DRAFT
MAP Series of PWR Shipping Packages
Amendment to Certificate of Compliance
USA/9319/B(U)F-96
Docket 71-9319

June 9, 2009
Rockville, MD

Revised Licensing Documents

Internal Door Hinge and Latch Configuration Drawing 9045399 Revision 1

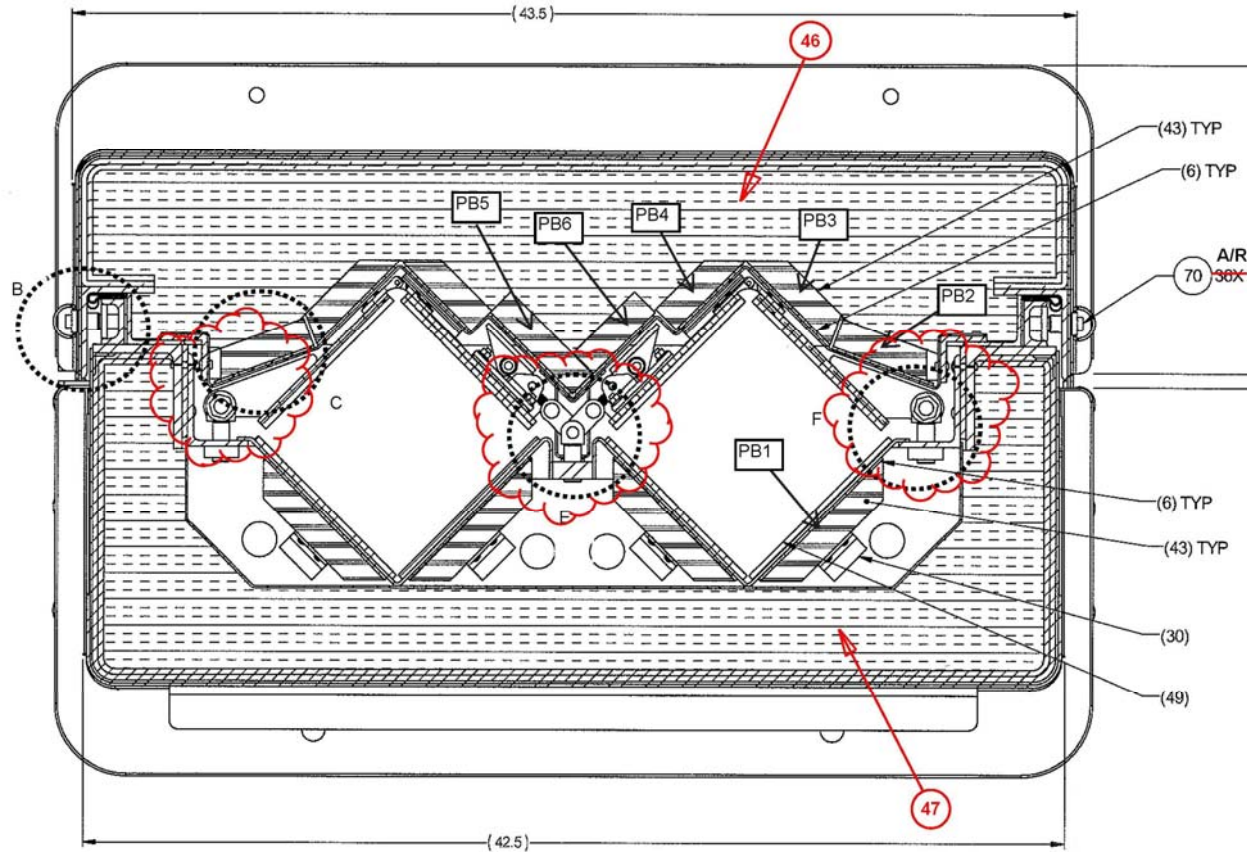
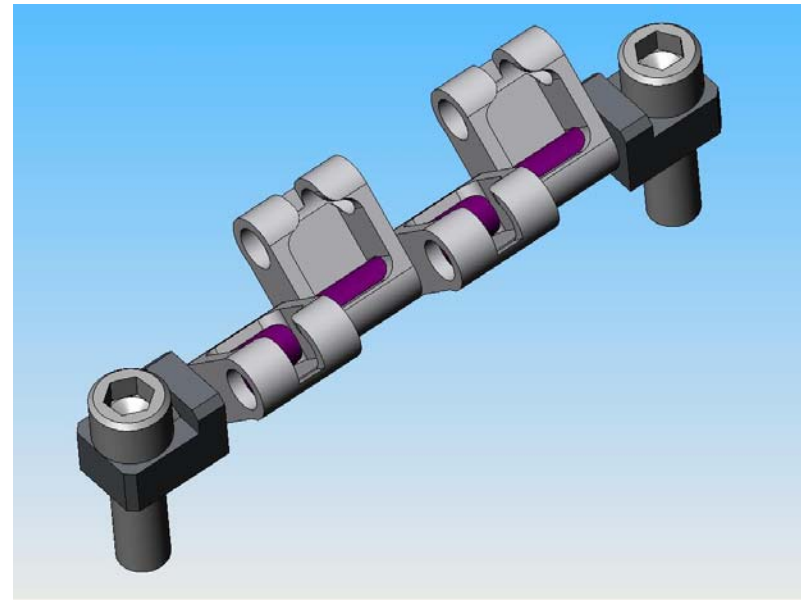
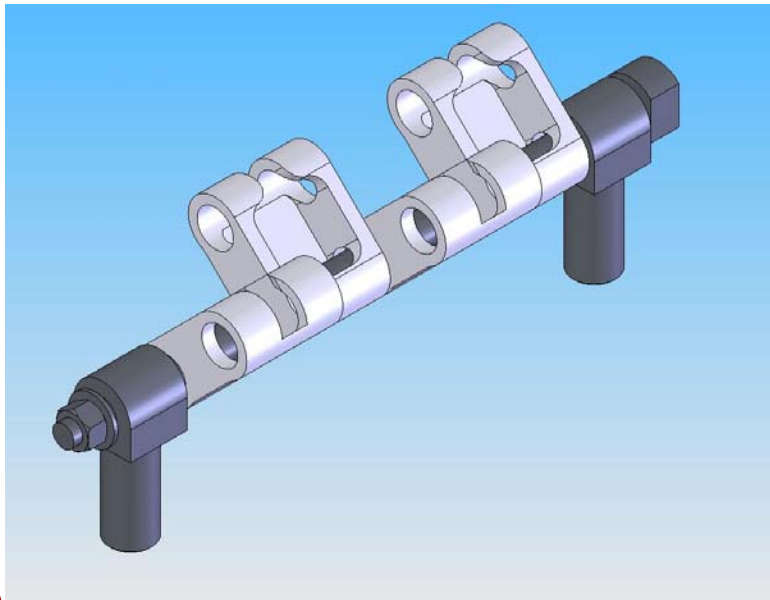
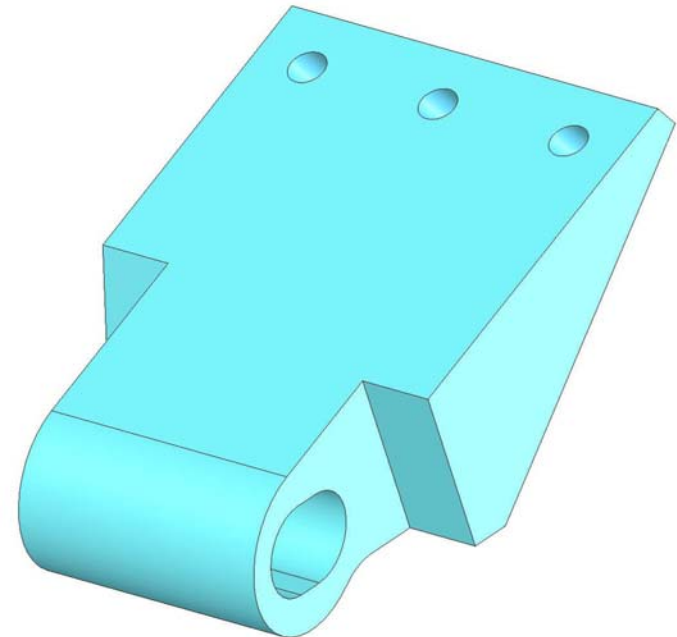
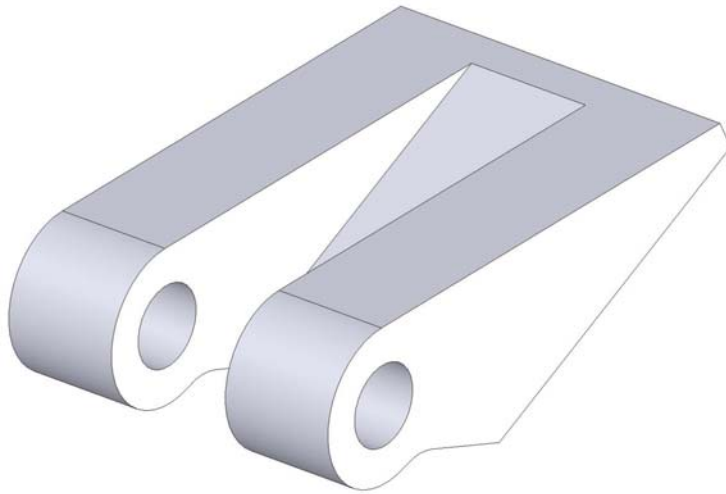
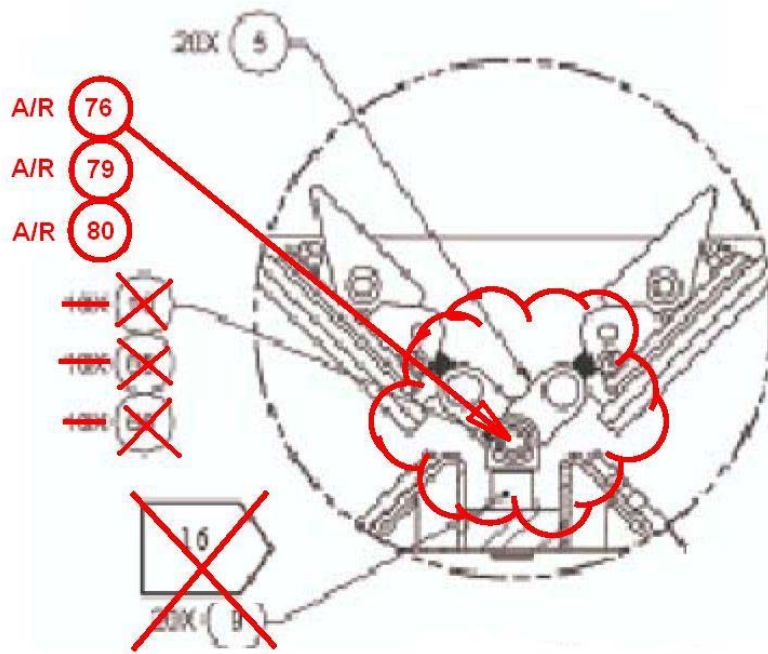
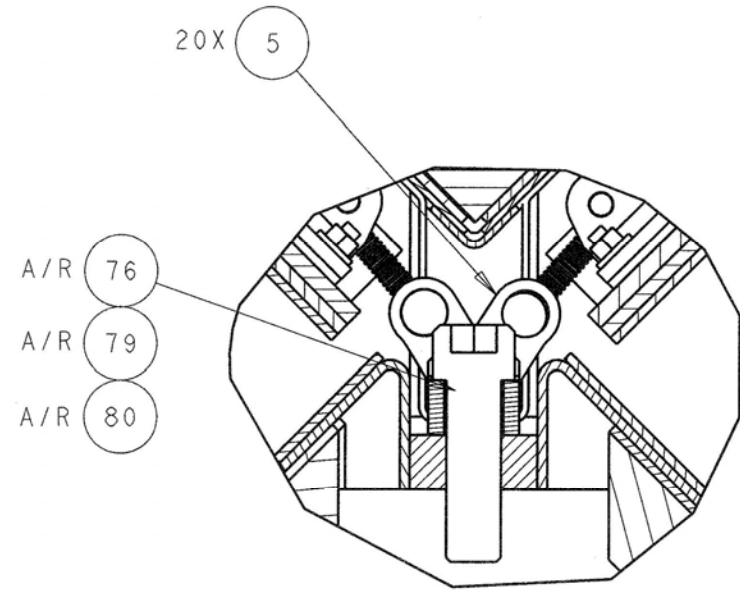
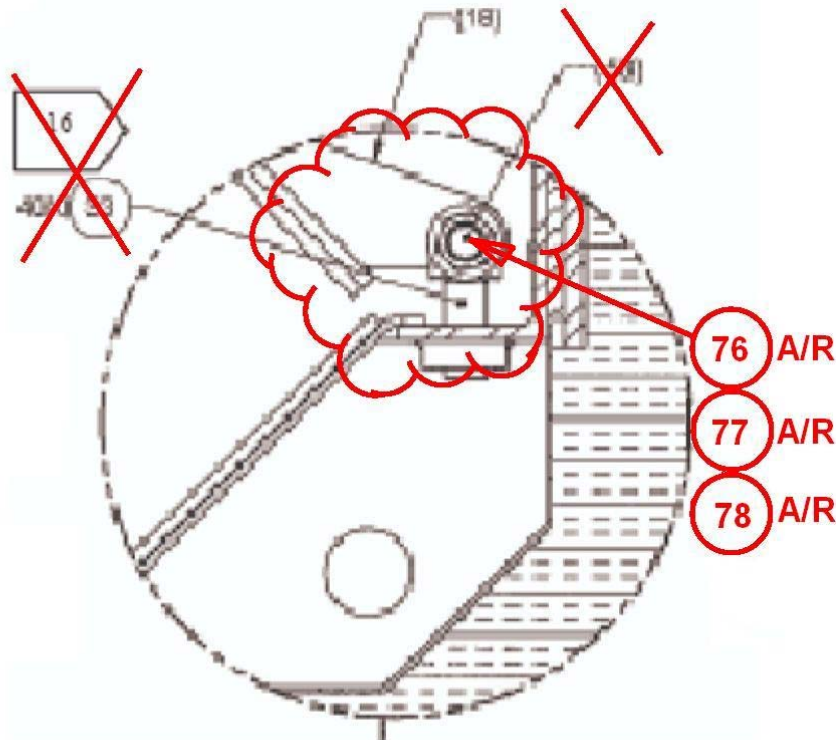
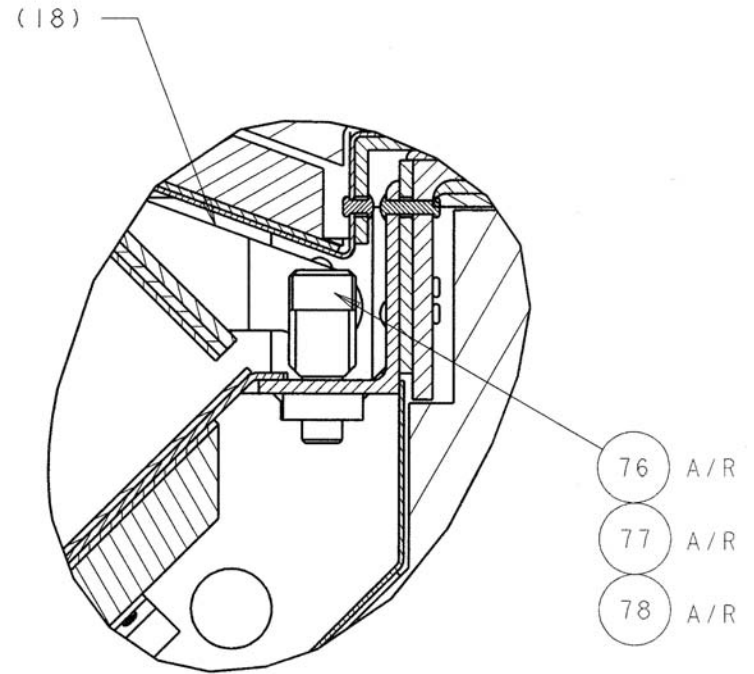
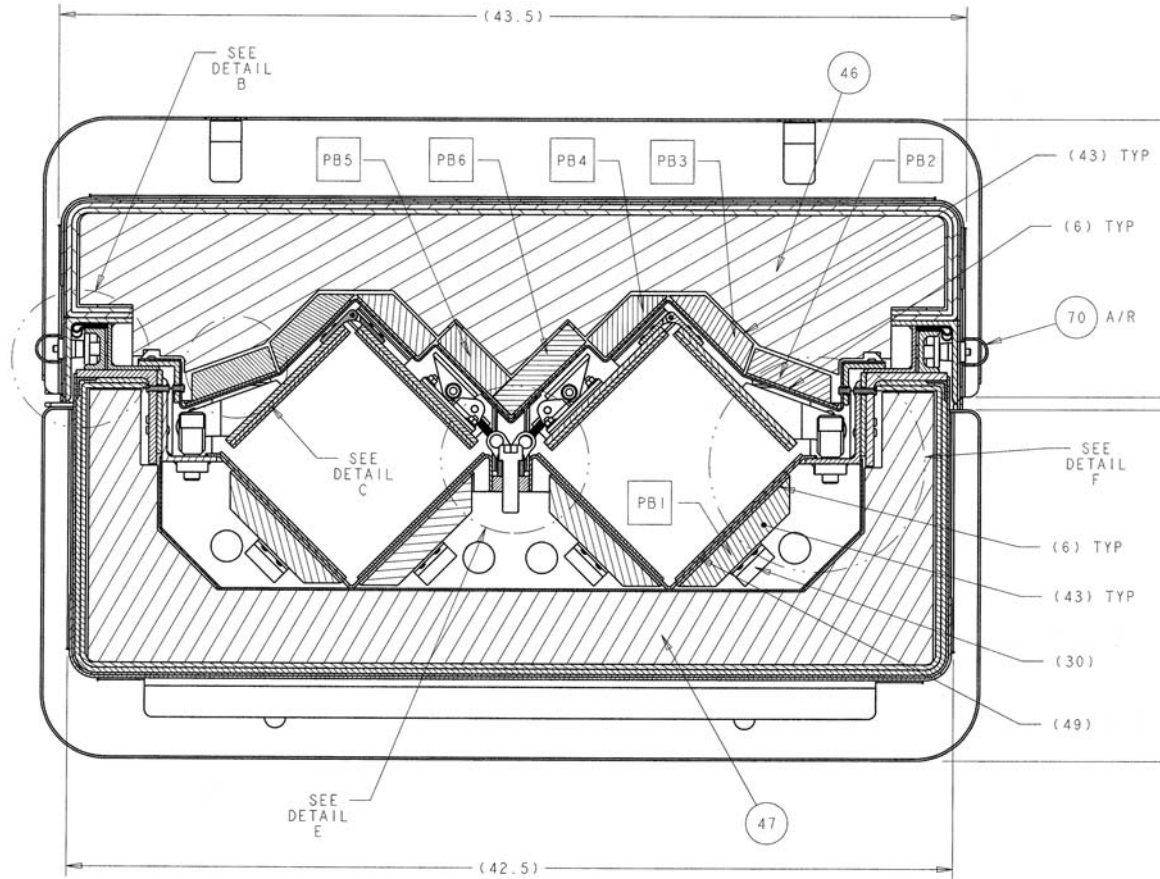
- ◆ ***Updated to reflect current door hinge configuration and applicable items***
- ◆ ***Added items 76 – 80***
- ◆ ***Added balloons for identification of components***

- ◆ ***New door hinge configuration designed for ease of use and to improve product quality***

No impact regarding the performance of the container under accident conditions.

Drawing 9045399 Revision 1

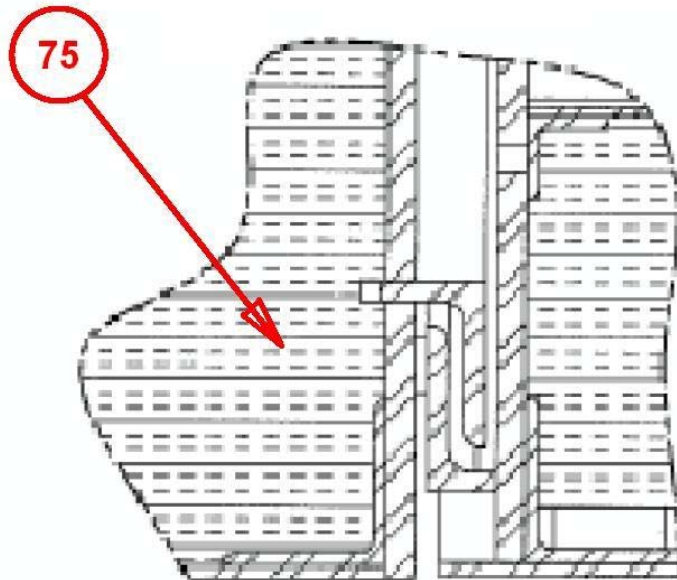
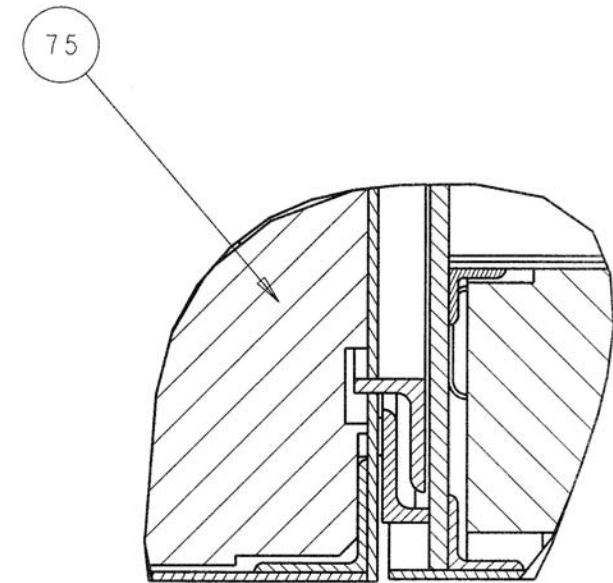
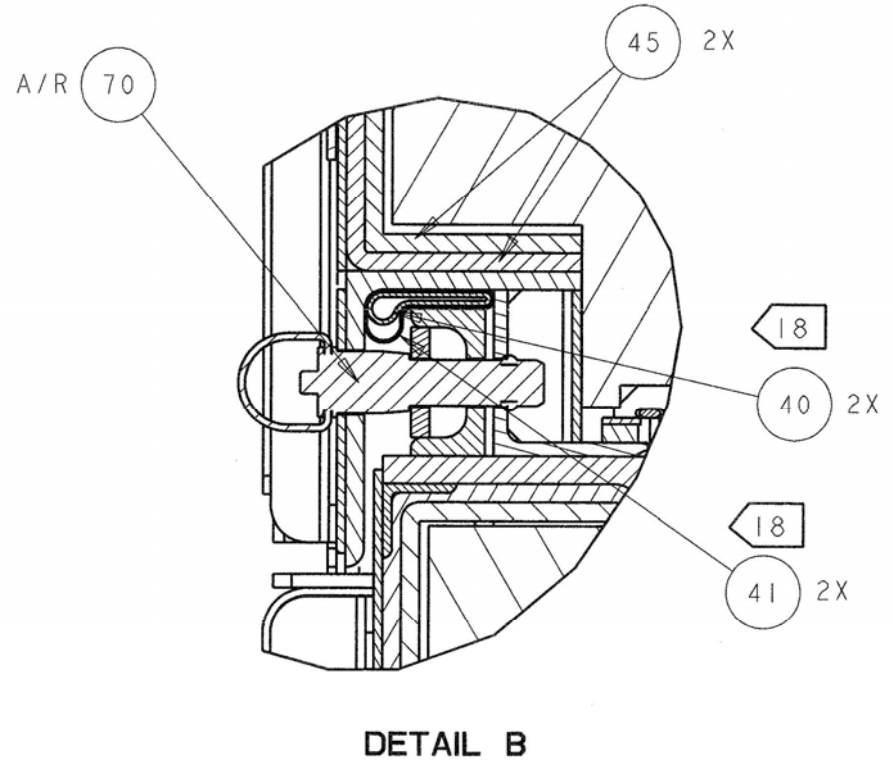
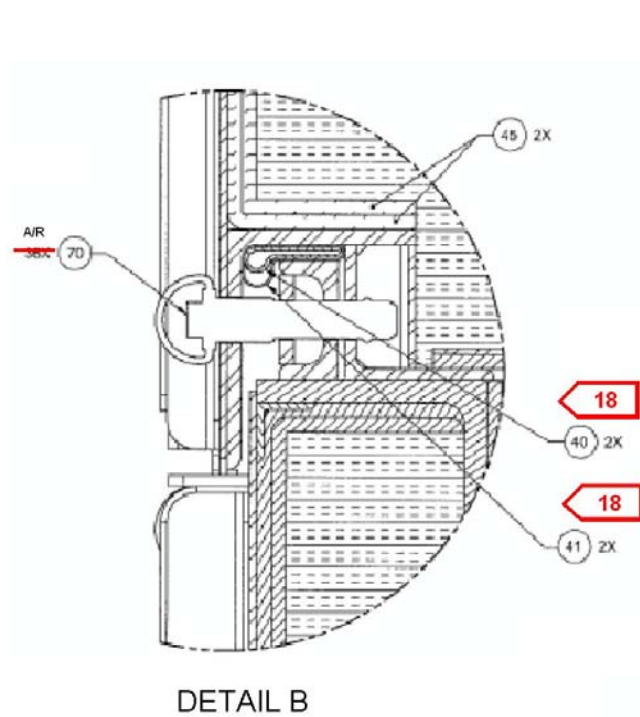
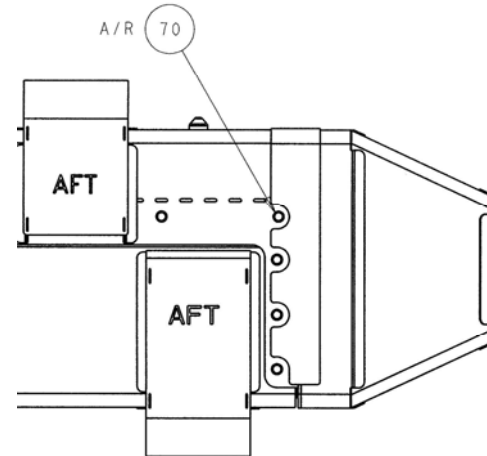
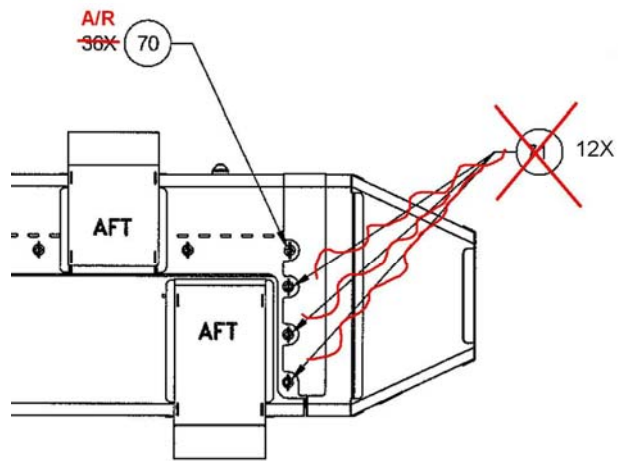
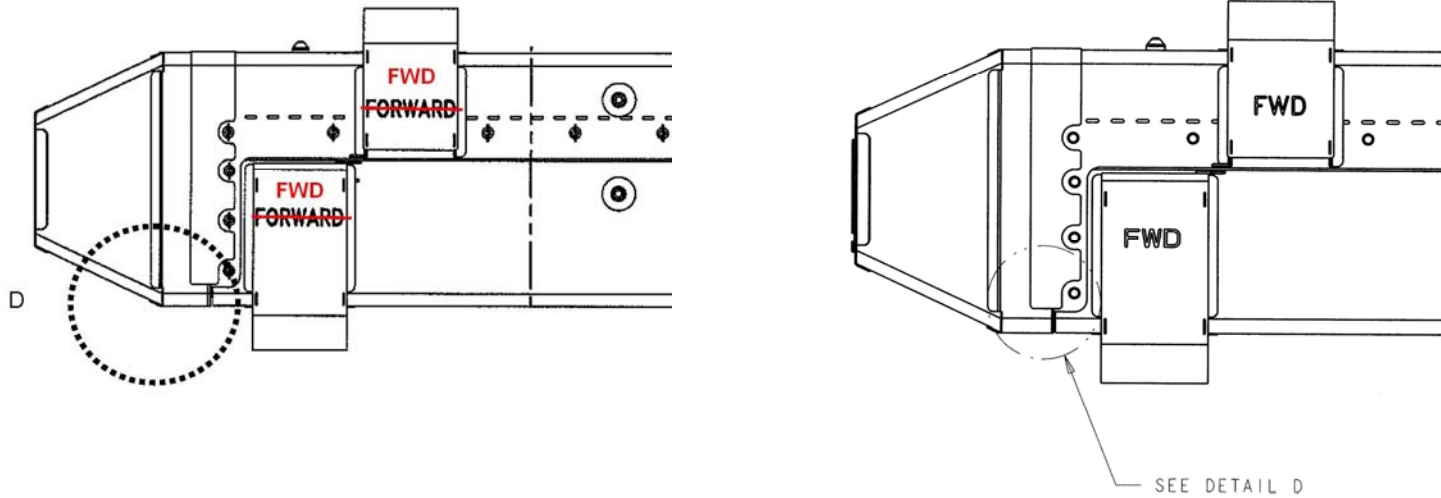
- ◆ *Recreated in CAD system*
- ◆ *Added “A/R” on applicable quantities*
- ◆ *“FWD” was “FORWARD”*
- ◆ *Added balloons and note pointers*

- ◆ *Clarifications*
- ◆ *Allow for viewing improvement*
- ◆ *Omit quantities of applicable components to differentiate between MAP-12 and MAP-13*

No impact regarding the performance of the container under accident conditions.
